**STATE OF TENNESSEE  
DEPARTMENT OF TRANSPORTATION  
DESIGN DIVISION**

**INSTRUCTIONAL BULLETIN NO. 13-08**

**Regarding New and Revised Standard Drawings**

**Effective for the July 12<sup>th</sup> letting (May 1<sup>st</sup> turn-in),** the following Standard Drawings are new or revised and Section V of the Design Guidelines is revised for this update.

PARALLEL DECELERATION LANE

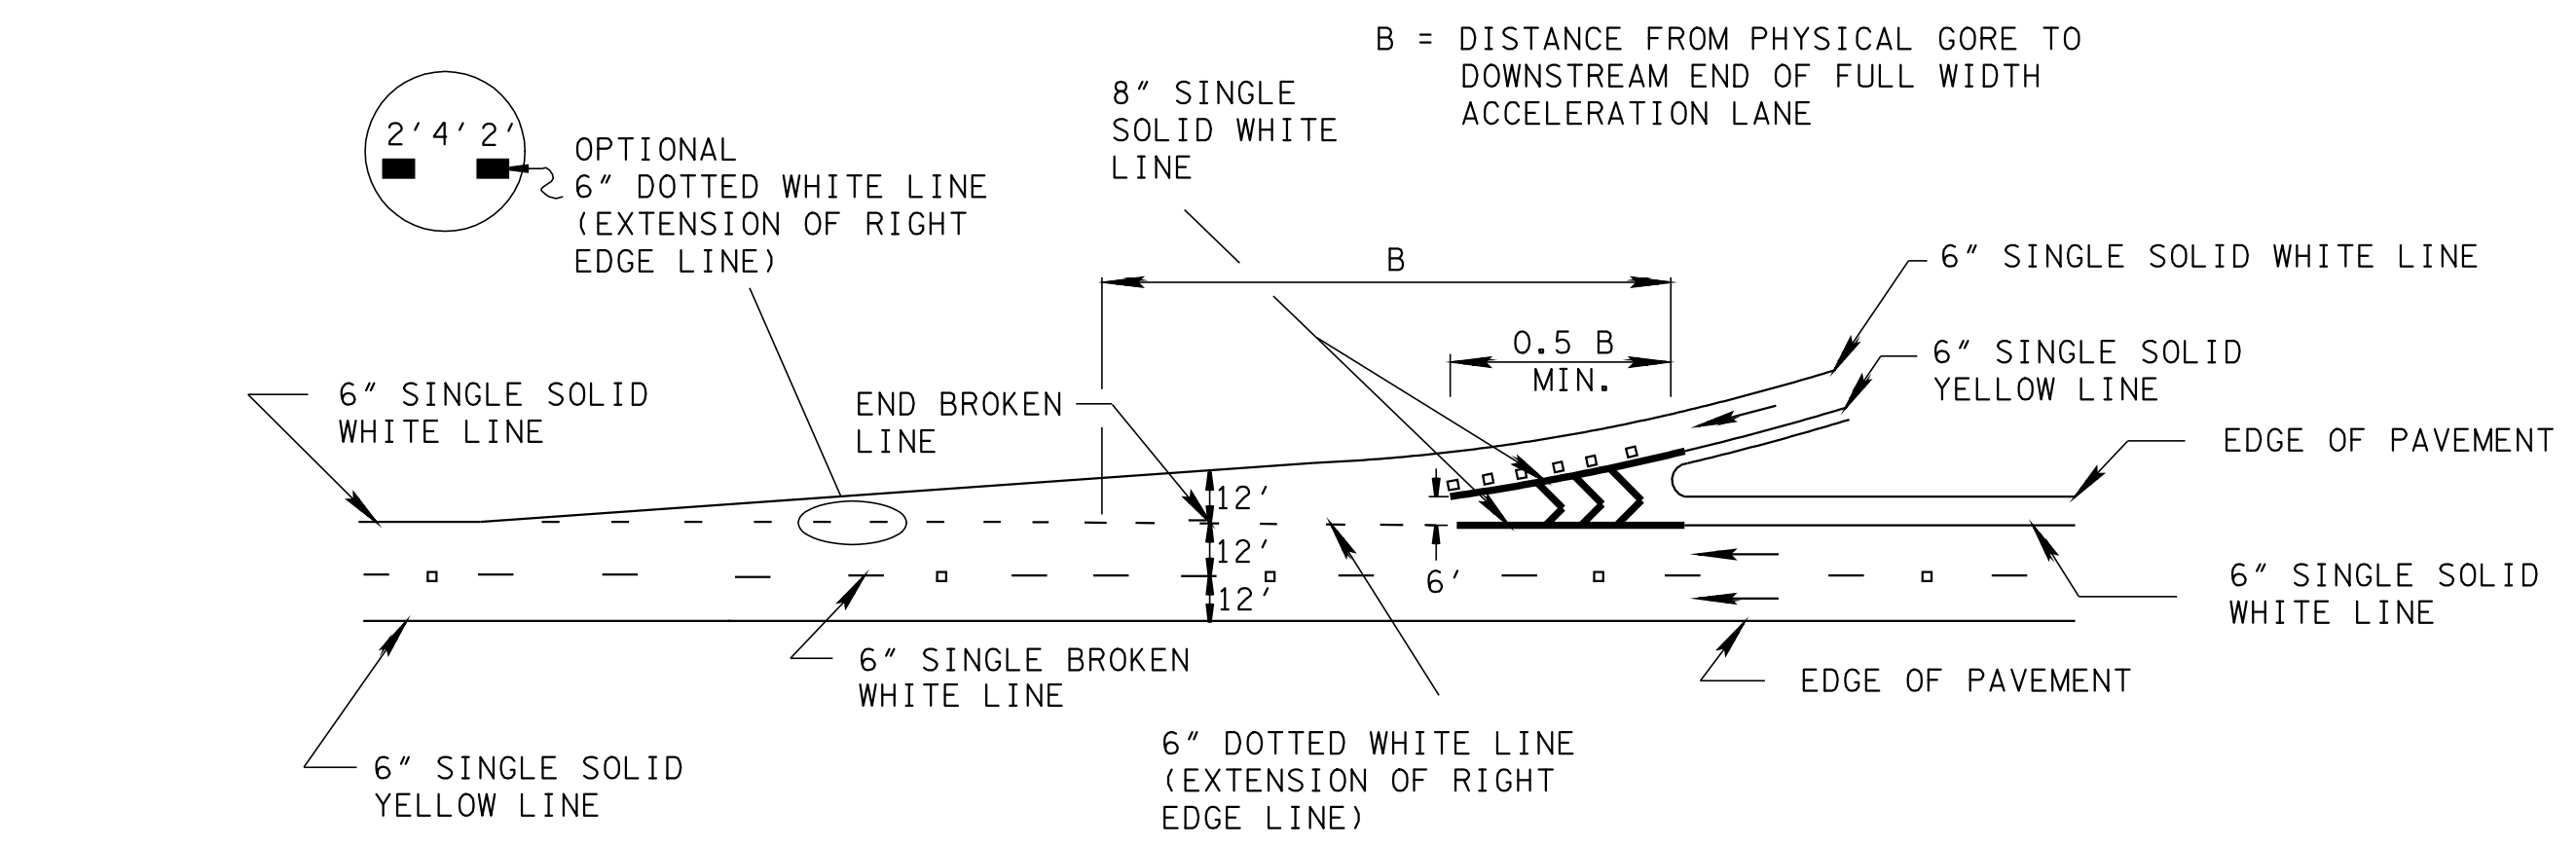
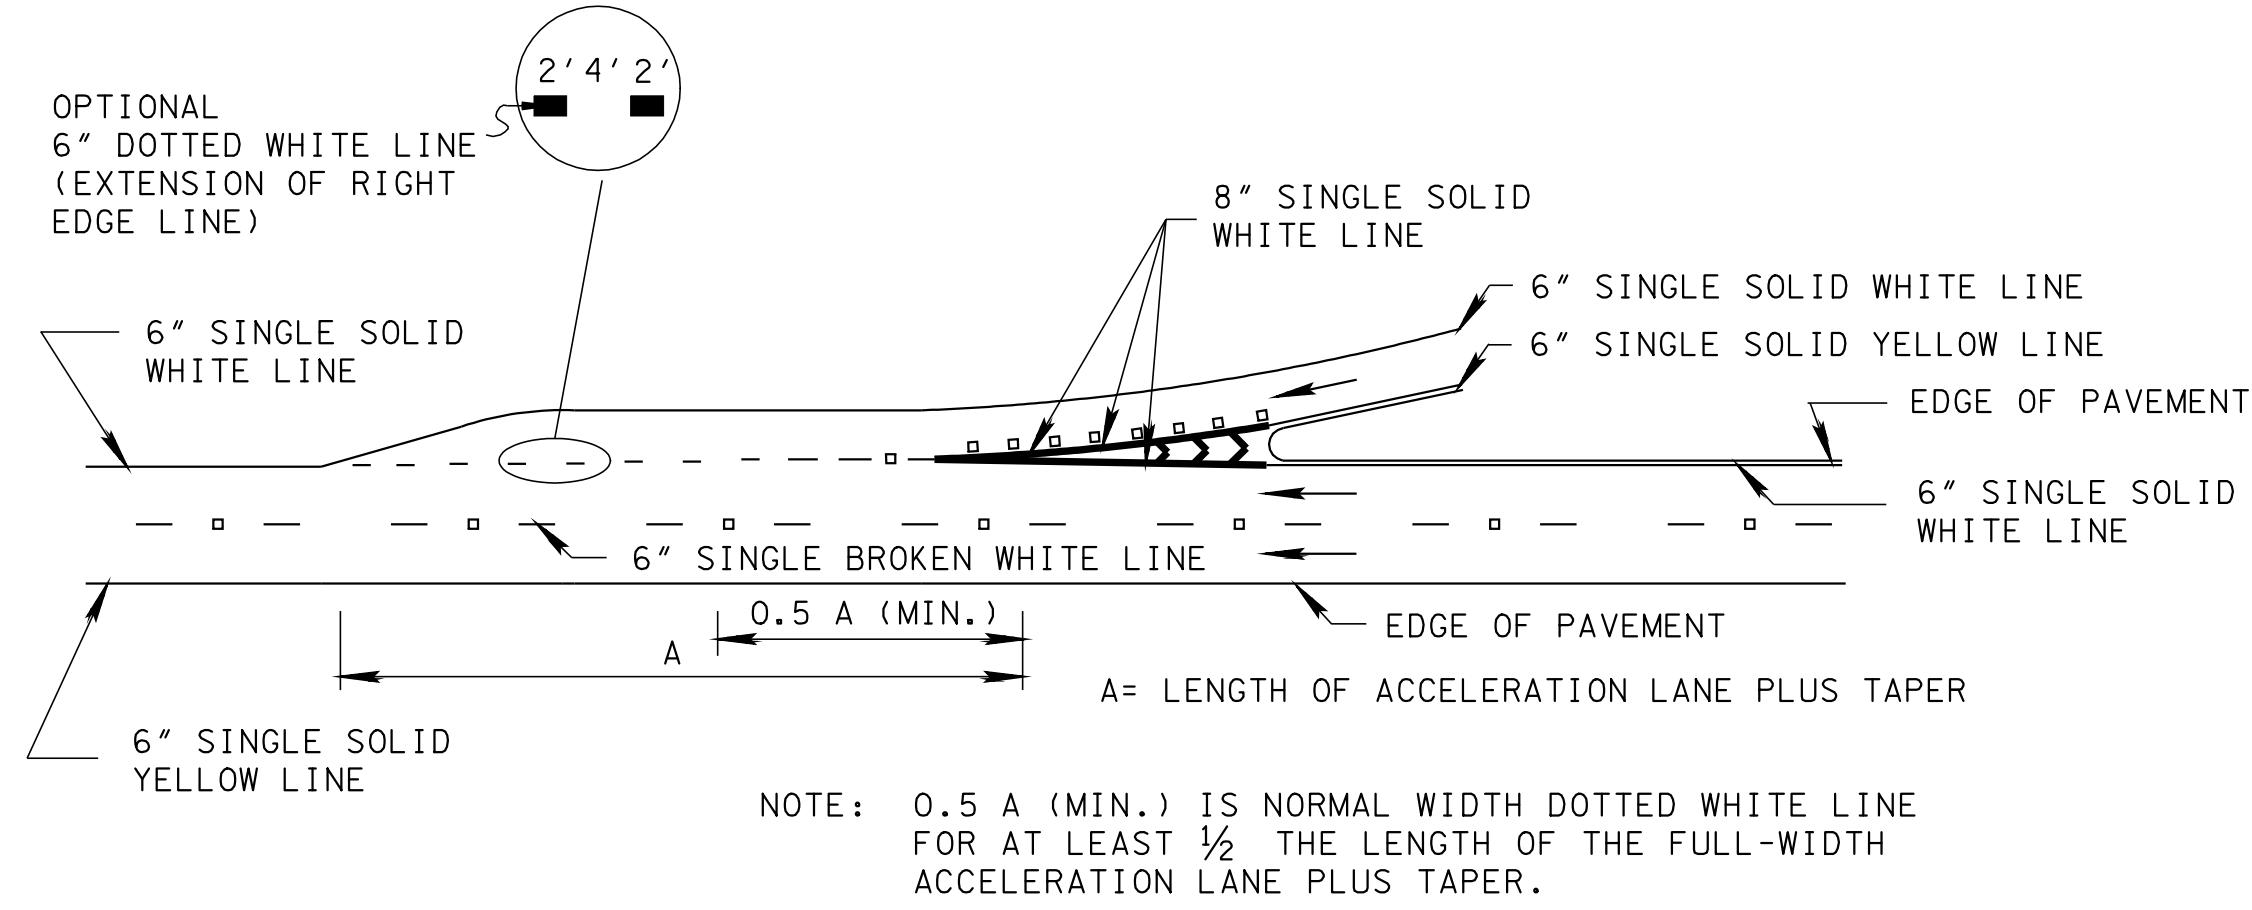
REV. 5-24-12: REVISED PAVEMENT MARKINGS FOR TAPERED ENTRANCE AND EXIT AND PARALLEL ENTRANCE AND EXIT RAMP.

REV. 6-22-12: REVISED SPACING FOR SNOW PLOWABLE MARKINGS IN EXIT ONLY DETAILS.

**SIGN PLACEMENT ON SHARED-USE PATHS**  
(SEE RD-TS-8 FOR TYPICAL CROSS SECTION DETAILS)

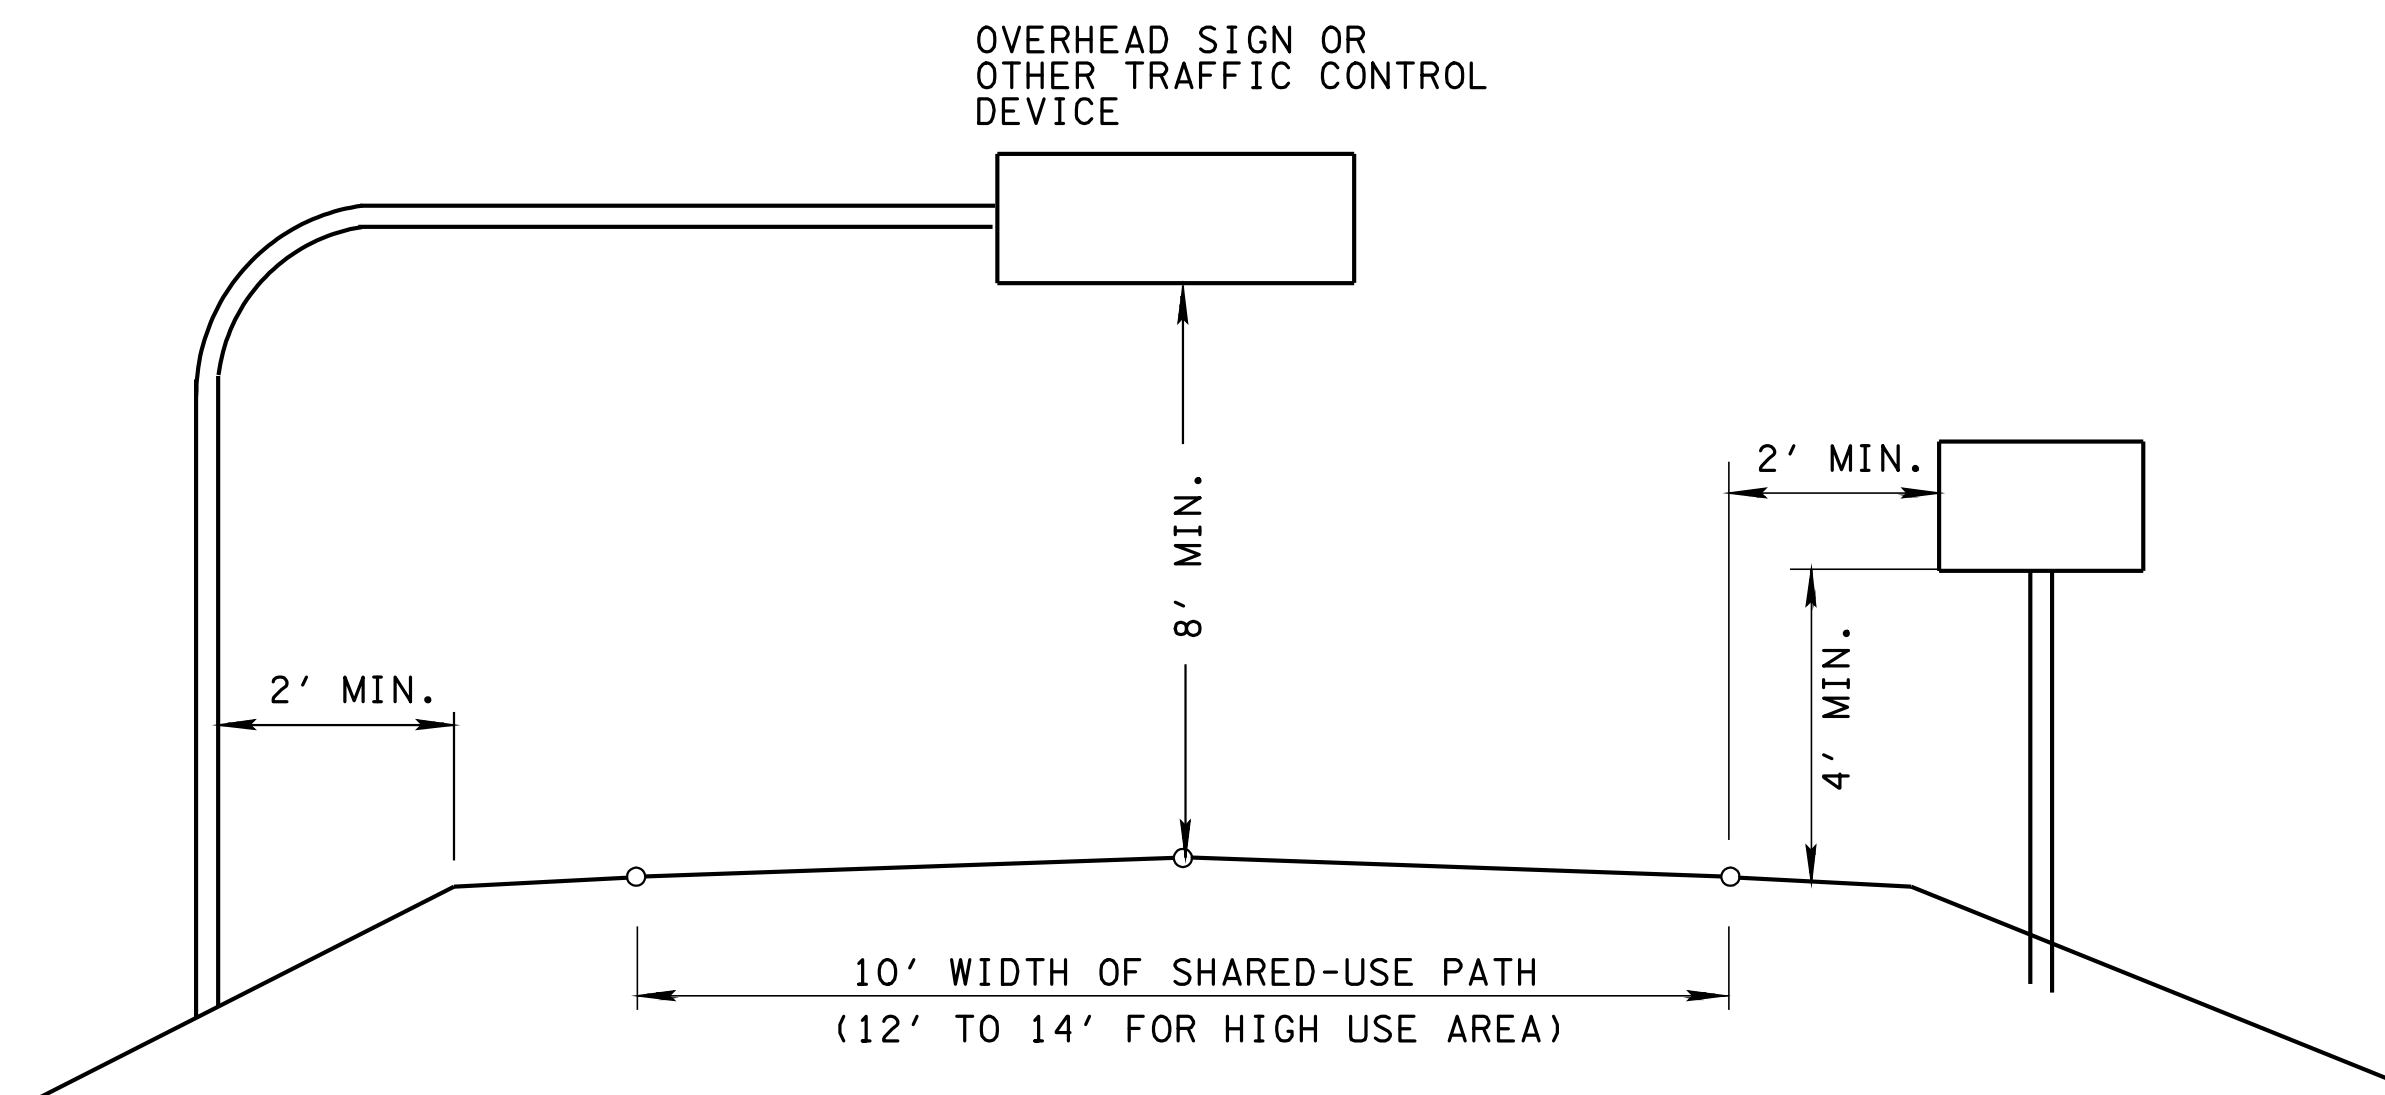
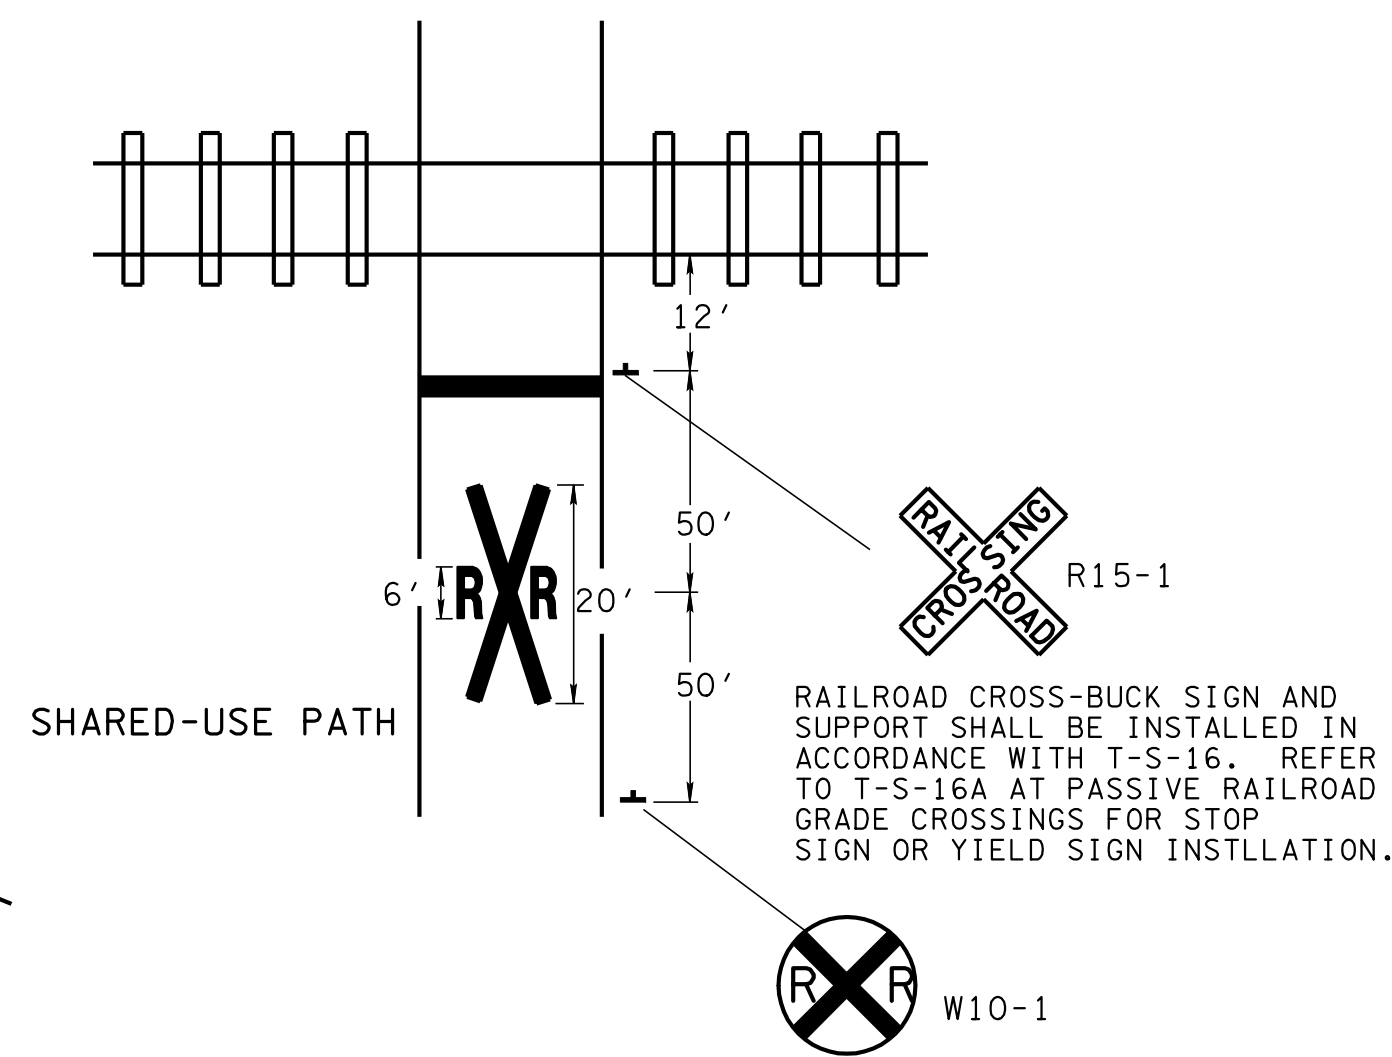
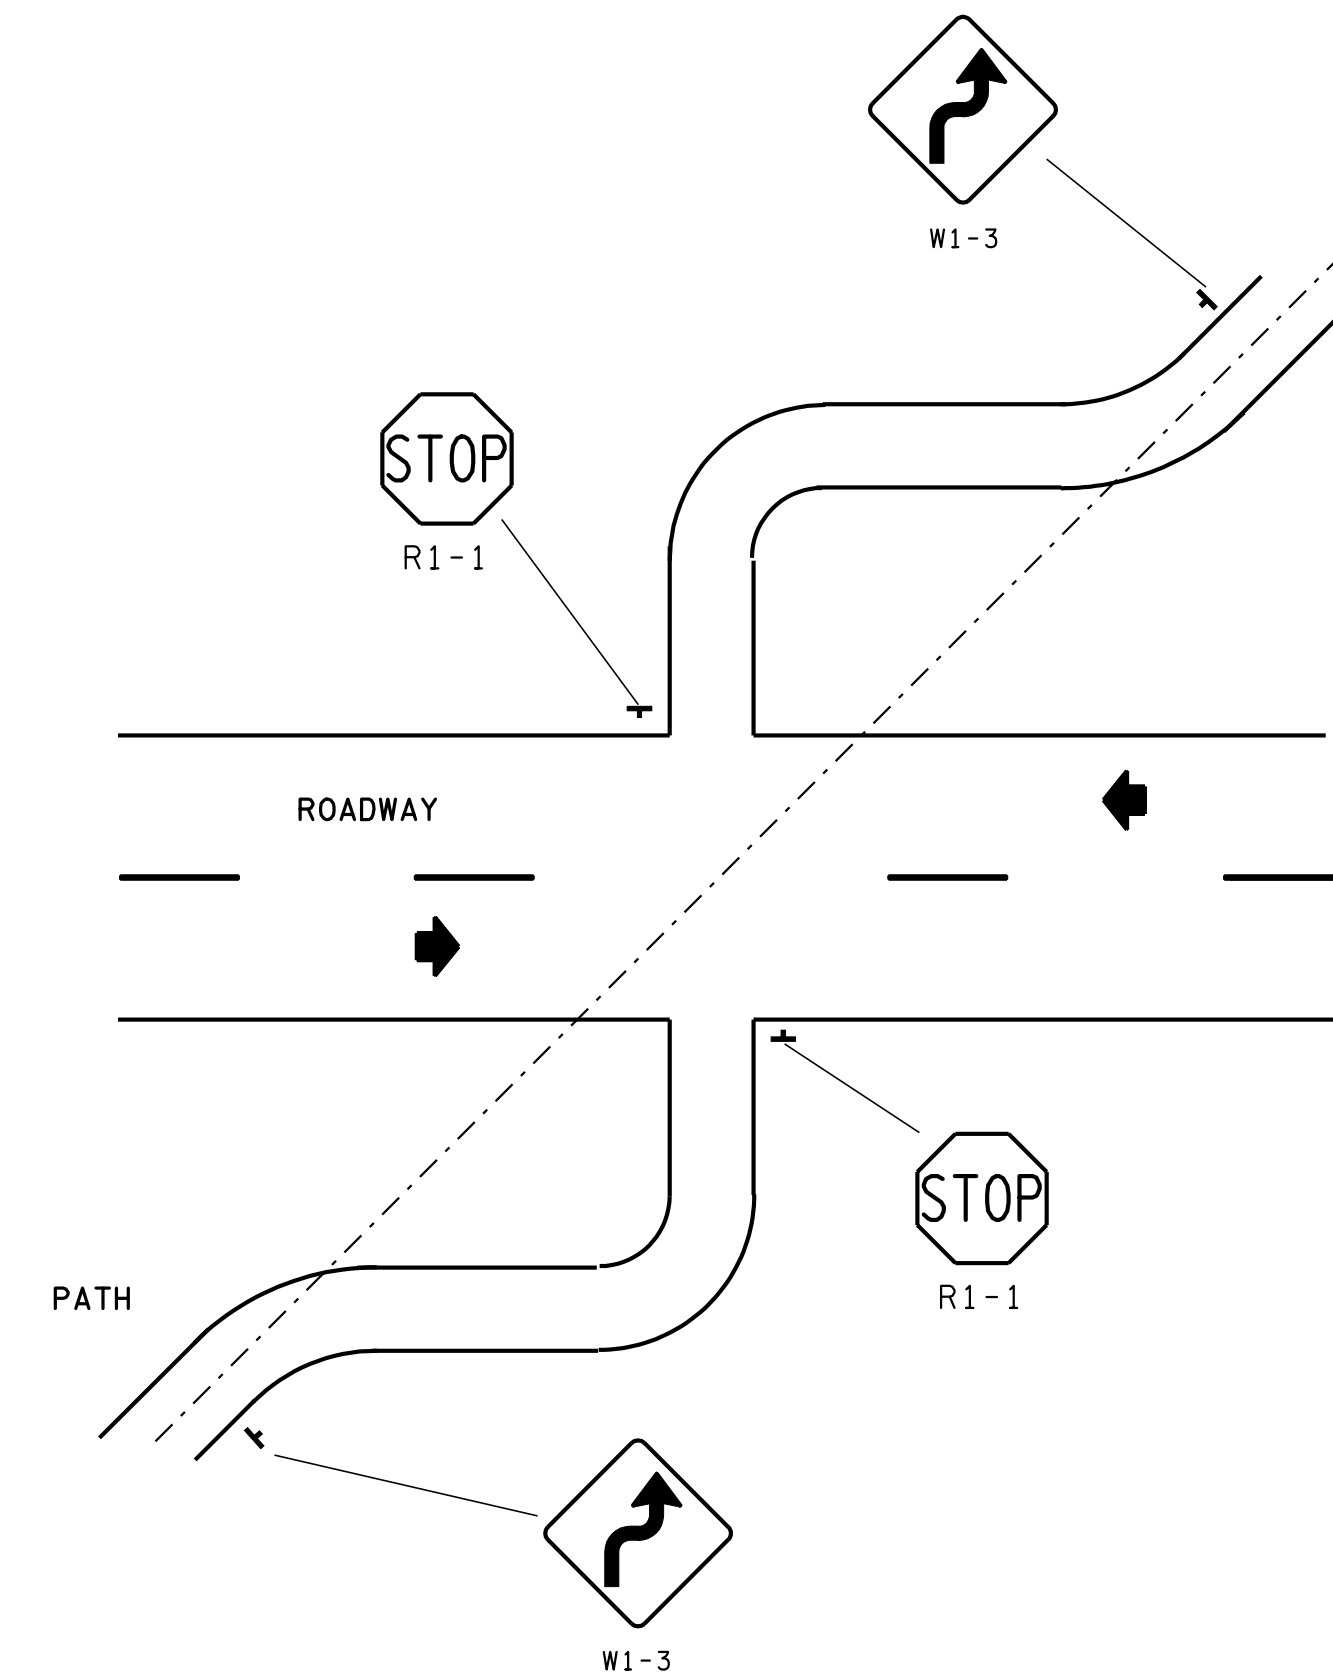
REV. 6-15-12: REVISED INTERSECTION SIGNING FOR 2012 EDITION OF GUIDE FOR THE DEVELOPMENT OF BICYCLE FACILITIES.
